SEWAGE DISPOSAL SYSTEM

SUBDIVISION Riggs Property LOT 41 ROAD 2025 Meadow Tree Court

Approved Septic System Plan  
Howard County Health Department

PROPERTY: Wissman Residence  
2025 Meadow Tree Court  
Cookeville, MD 21723

**PLAN**  
SCALE: 1"=30'

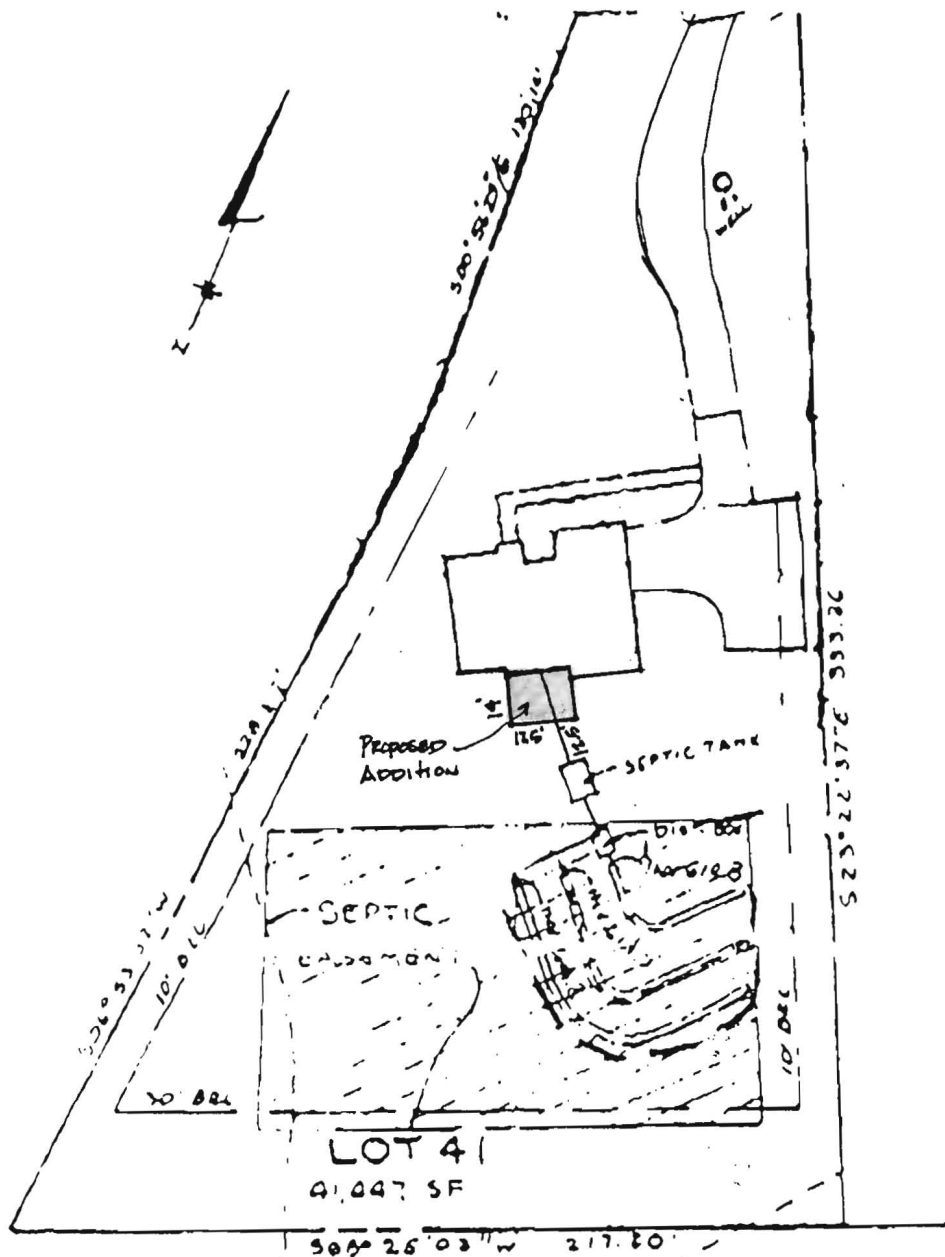
REMARKS: 5/18/98 Inv. out of house too deep by 2' - test hole dug, water @ 10.0' - can not  
put system deeper in ground - builder needs to change plumbing shu

INPE; P.A. 3.0' below grade, casing 1.0' above grade, has 2 piece cap, line  
sleeved out of house (KM)

5.22.98 has house connection ok to cover all work (KM)

**PLAN**  
 SCALE: 1" = 50'

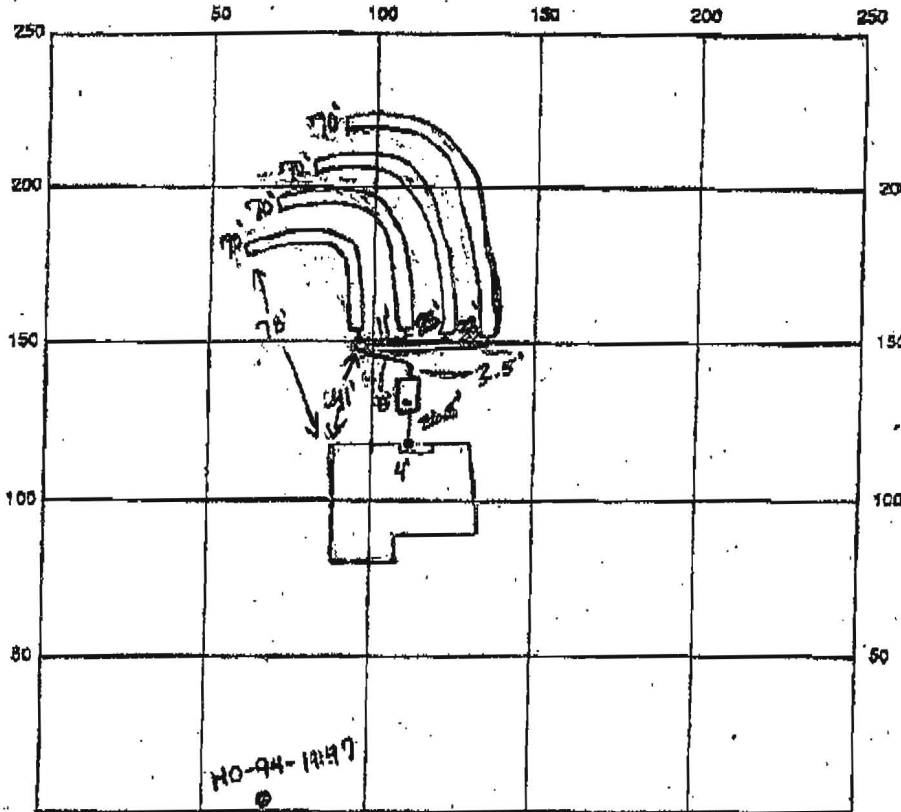
REMARKS: 5/18/98 In out of house too deep by 2' - test hole dug water @ 10.0' - can not  
out system deeper in ground - builder needs to change plumbing etc

WPE: P.A. 3.0' below grade, casing 1.0' above grade, has 2 piece cap, line  
slowed out of house (KM)

5-22-98 has house connection ok to cover all work (KM)
